CODE COMPLIANCE CERTIFICATE Section 43(3), Building Act 1991

Project Descrn: NEW CONSTRUCTION
BEING STAGE 1 OF AN INTENDED 1 STAGES
SHOWHOME/DWELLING (ON LOT 6)

Project Location: 52 KAKARIKI GR WAIKANAE

SECTION C-C. SCALE 1:50.

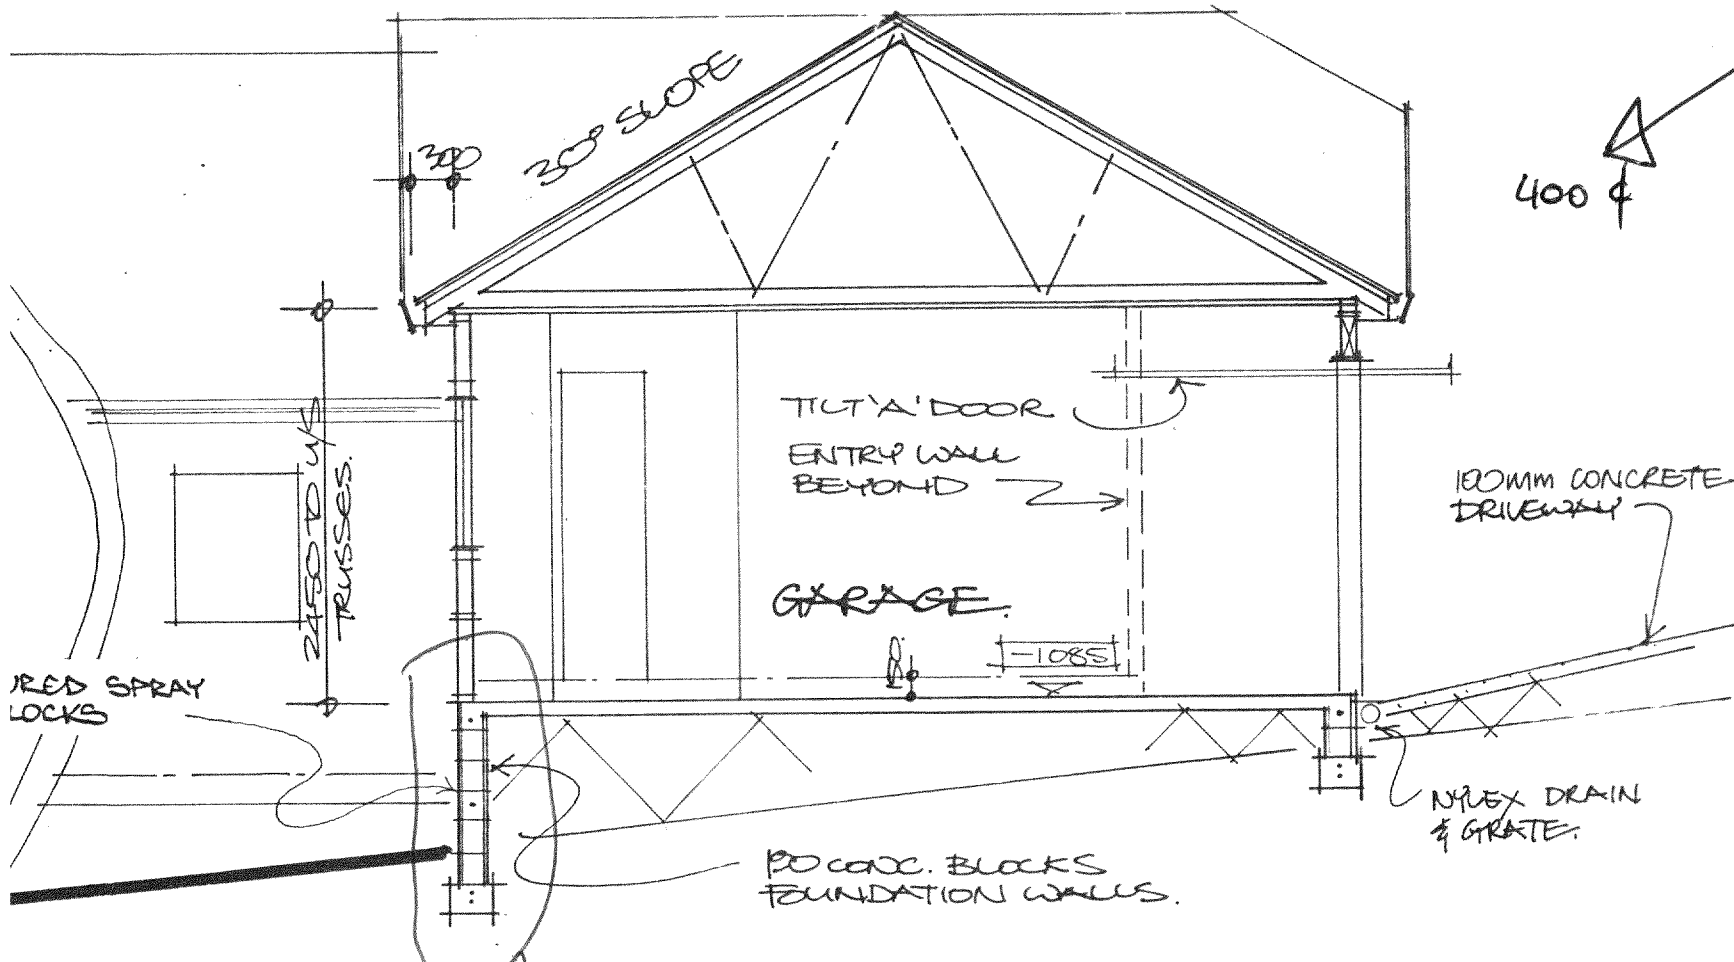
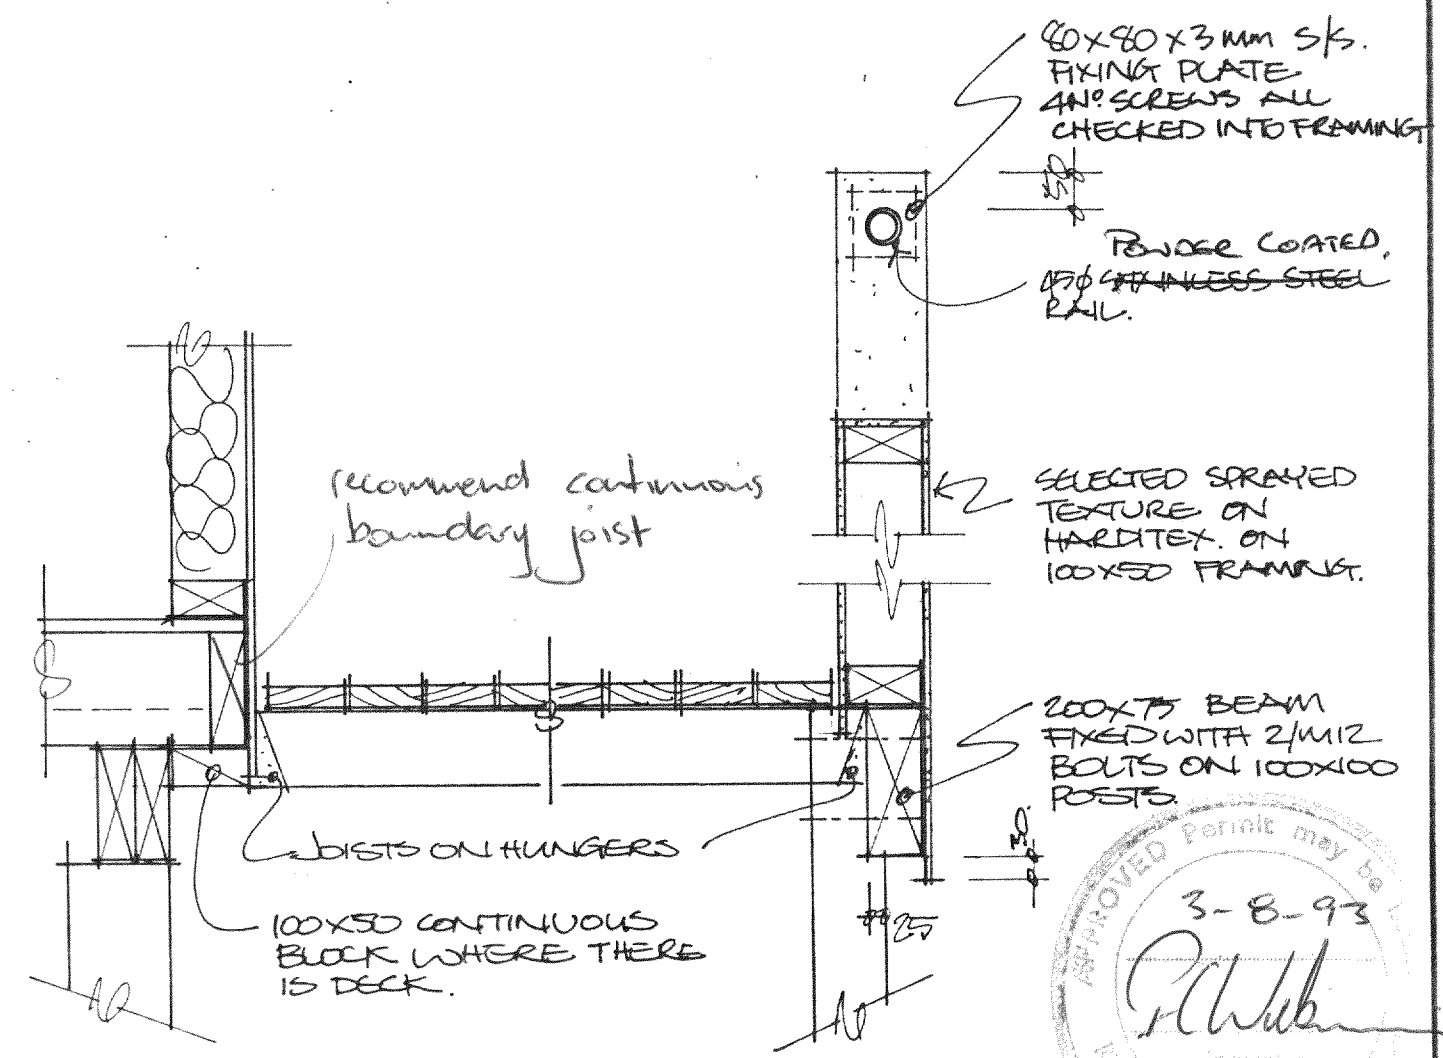
Vertical reinforcing to be D12's @ 400cs this face and returning 1.5 metres down each side wall. Otherwise as detailed Sheet 4 OK.

ELEVATION THREE
SCALE 1:100

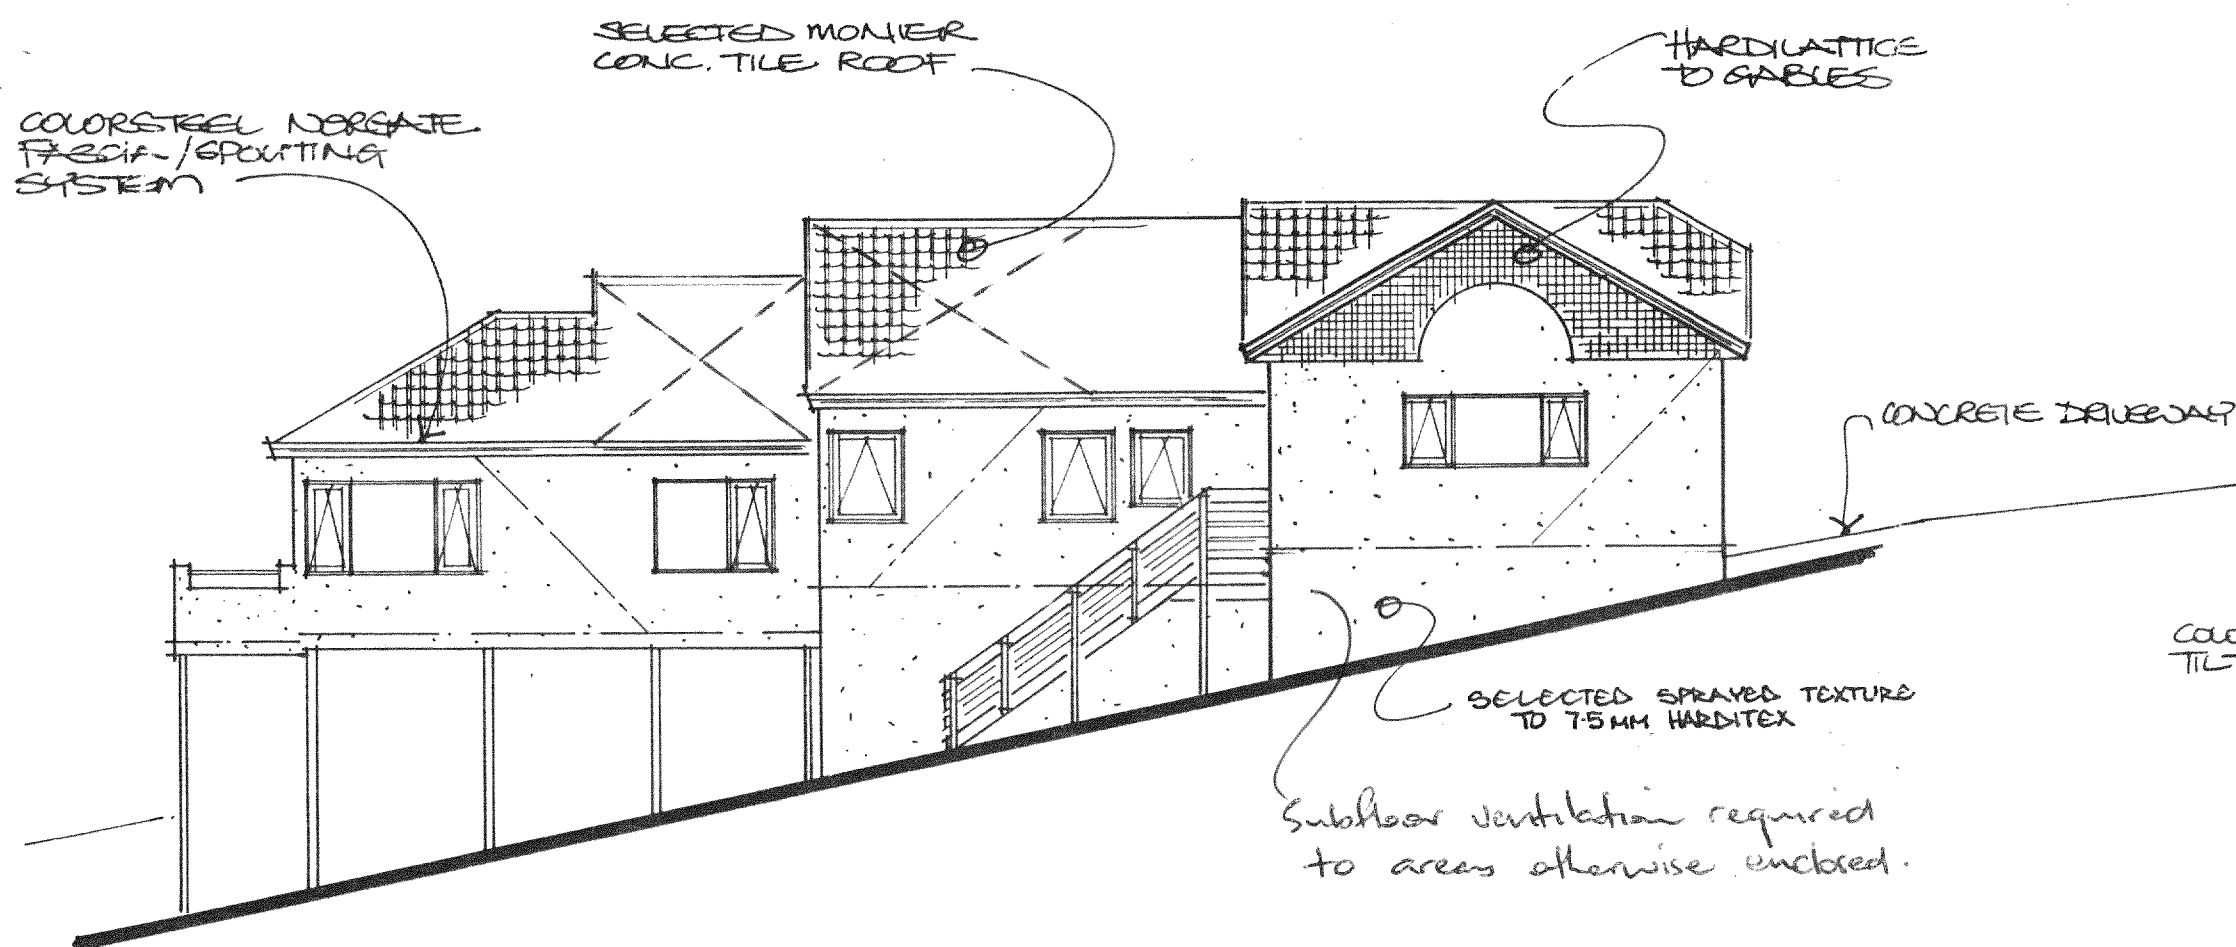
Roof bracing to NZS. 3604:1990
Note also Roof Space bracing
requirements for Heavy Gabled Roofs
and conform.

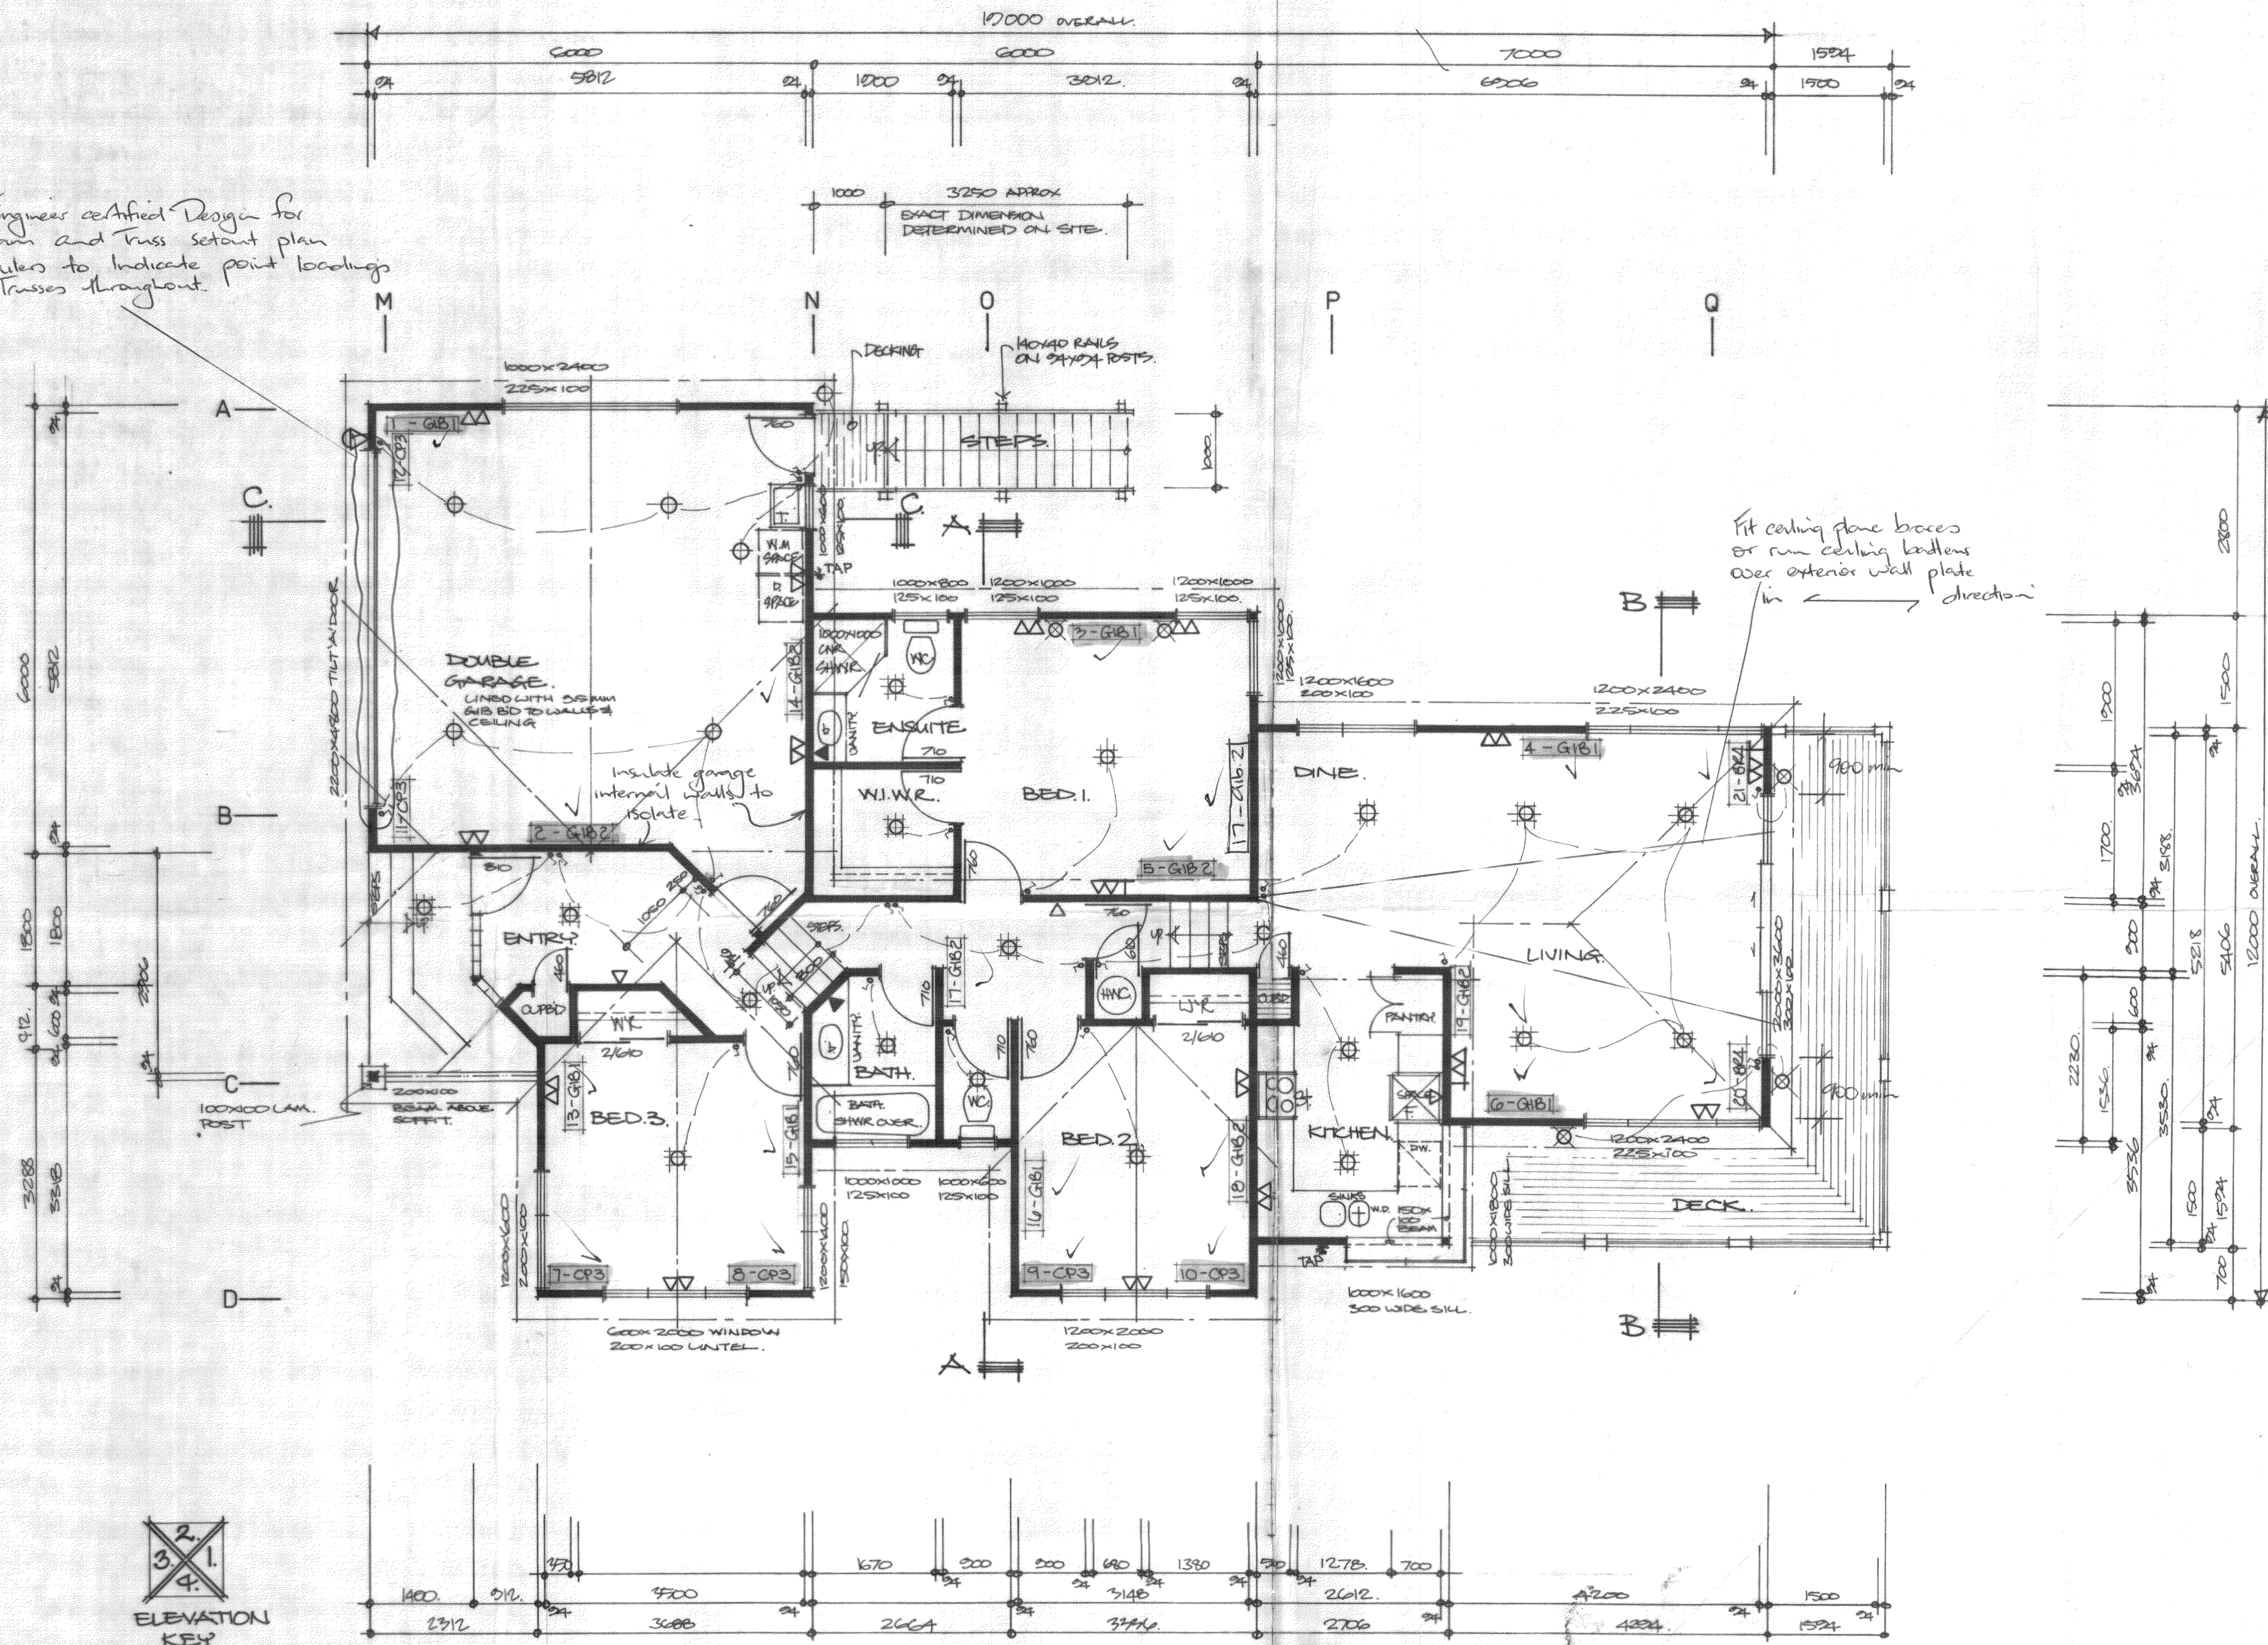
vide Engineer certified Design for
g. Beam and Truss setout plan
Reminders to indicate point loadings
over Trusses throughout.
